Subject: Zoning By-law Amendment - 1649 Montreal Road and 741 Blair Road

File Number: ACS2022-PIE-PS-0100

Report to Planning Committee on 8 September 2022

- 1. That Planning Committee recommend Council refuse an amendment to Zoning By-law 2008-250 for 1649 Montreal Road and 741 Blair Road, as shown in Document 1, to permit a 26-storey mixed-use building, as detailed in Documents 2 and 3.**

Document 5 – Conceptual Models and Perspectives of 26-Storey Building

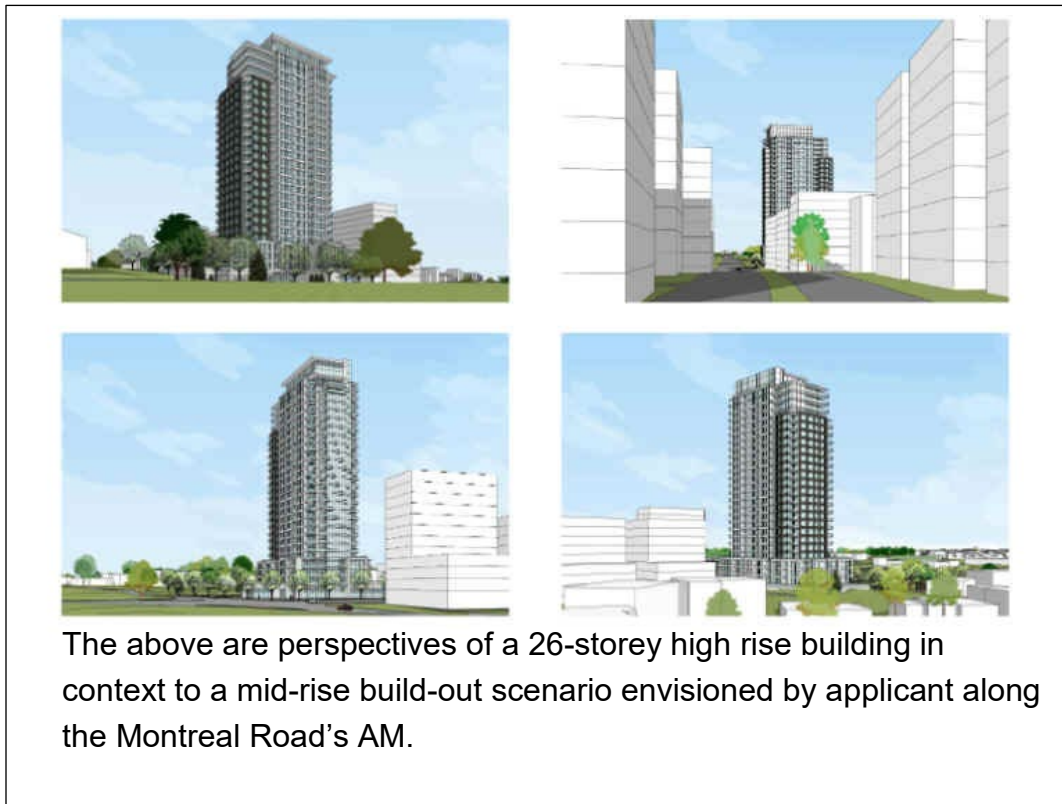
The above is a model showing existing typologies with a full-build-out scenario envisioned by applicant along the Montreal Road's AM corridor as well as its request for a 26-storey high rise building.

The above are perspectives of a 26-storey high rise building in context to a mid-rise build-out scenario envisioned by applicant along the Montreal Road's AM.
